JLG 11050B-5 Replace Building 4 Generator

St Cloud VAMC Project No. 656-12-211

RE: Amendment No. 1

Amendment No. 1

1
E3
GENERATOR BUILDING – ELECTRICAL
 1/8" = 1'-0"
 0' 4' 8' 16'

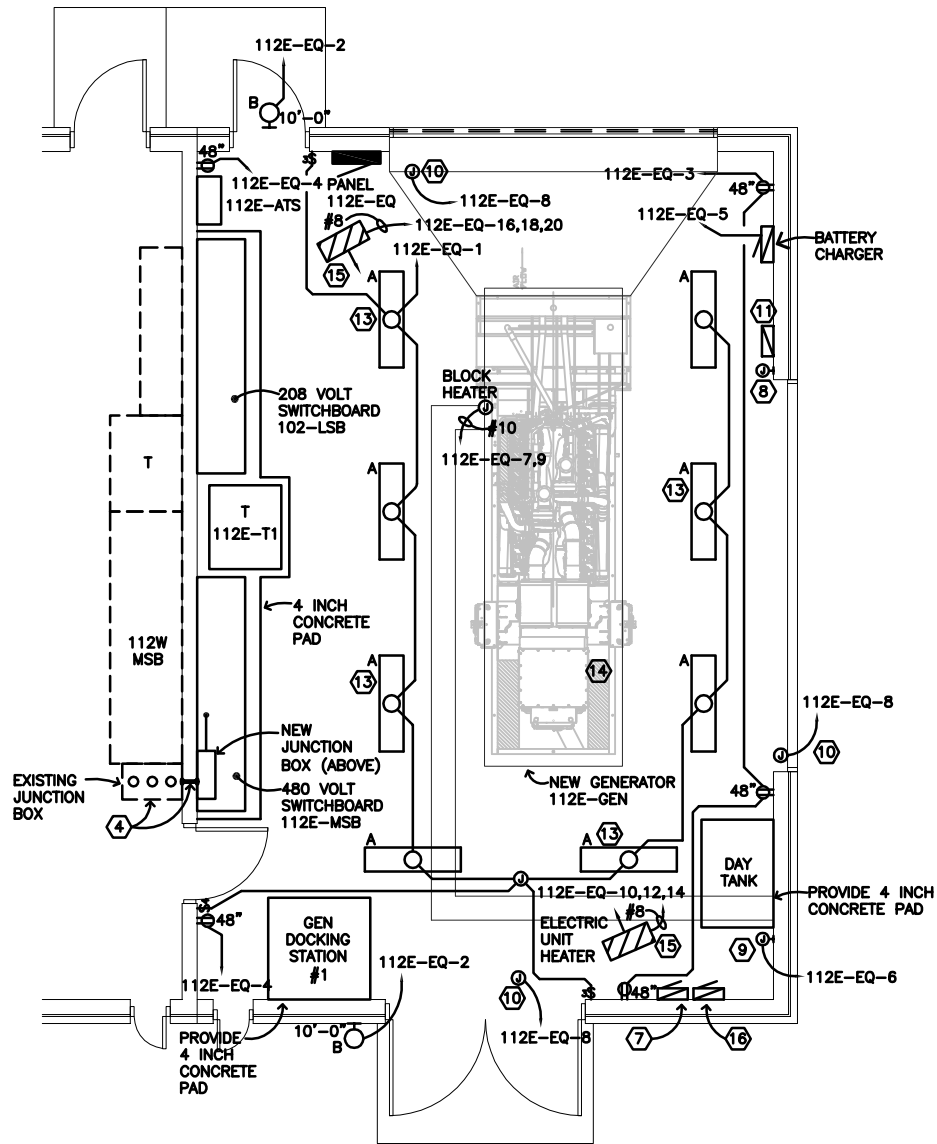
1. Floor Plan 1/E3
 - a. See attached revised drawing for correct Building name change and equipment designation changes.
 - b. Plan Note 3: Change the 102-LSB reference to 112E-LSB.
